# TDECQ Considerations Revisited

Norman L. Swenson, Ph.D.  
Norman Swenson Consulting  
Affiliations: Nokia and Point2  
10 March 2026

# Review of Cl 180.9.6.4

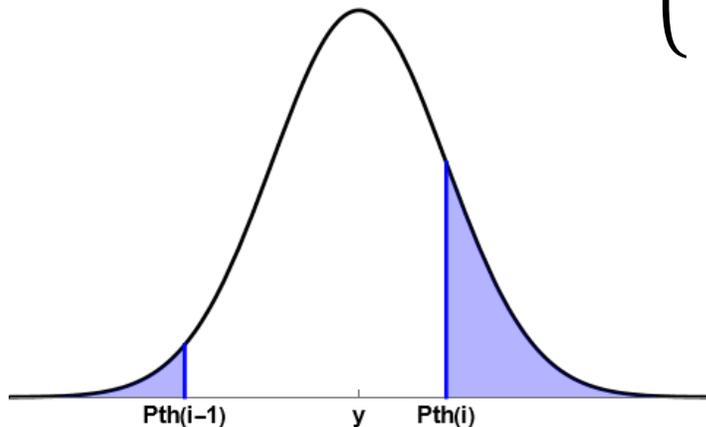
- $y$  is **assumed** to be in the correct zone to begin with ( $\hat{x}(y) = x$ )
  - This assumes that the eye is open
  - (Note: This assumption may be violated for TDECQ = 3.4dB)
- An error is made if the noise takes  $z$  out of the zone  $y$  is in initially

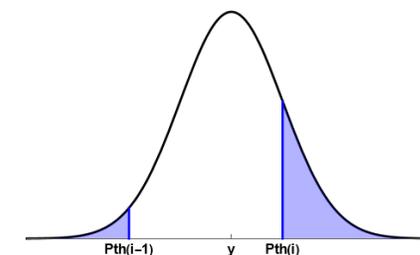
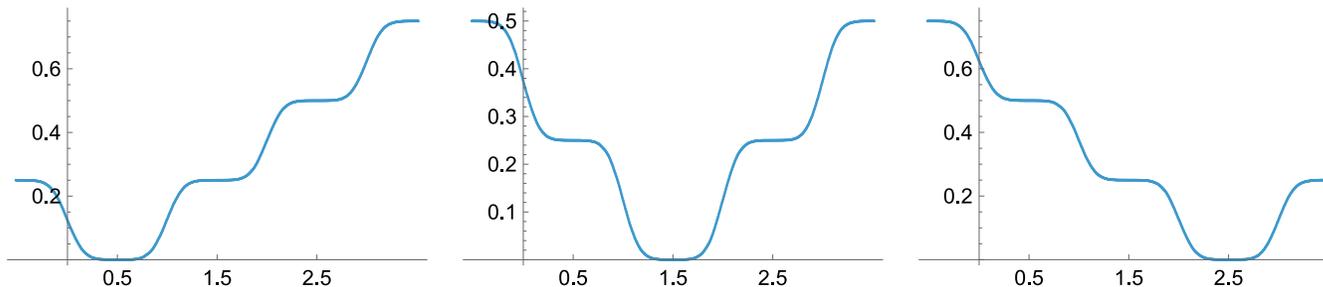
- Clause 180.9.6.4 does not compute symbol error rate as described on the previous slide
  - Instead, for each threshold, it calculates a “Cumulative Distribution Function”

- It then computes a weighted sum of the  $\text{CDF}(y_0, P_{\text{th}(i)})$  values over all  $y_0$ , where each value is weighted by the probability that the Gaussian noise is  $P_{\text{th}(i)} - y_0$
- It does this for each of three thresholds, then sums those three probabilities for the final probability of symbol error

- The two methods are not mathematically equivalent, because the tail of the gaussian distribution is being ignored at the largest magnitude  $y_k$  values (may be small effect)
- Also, the method computes the probability of error for each threshold as though that were the only threshold (a binary decision). It double counts or triple counts errors, depending on the region that the sample is in (a larger effect)
- Recommendation: Modify calculation of symbol error rate to that shown on slide 4 to improve readability and to ensure repeatability with different implementations
  - Study to quantify effect is ongoing
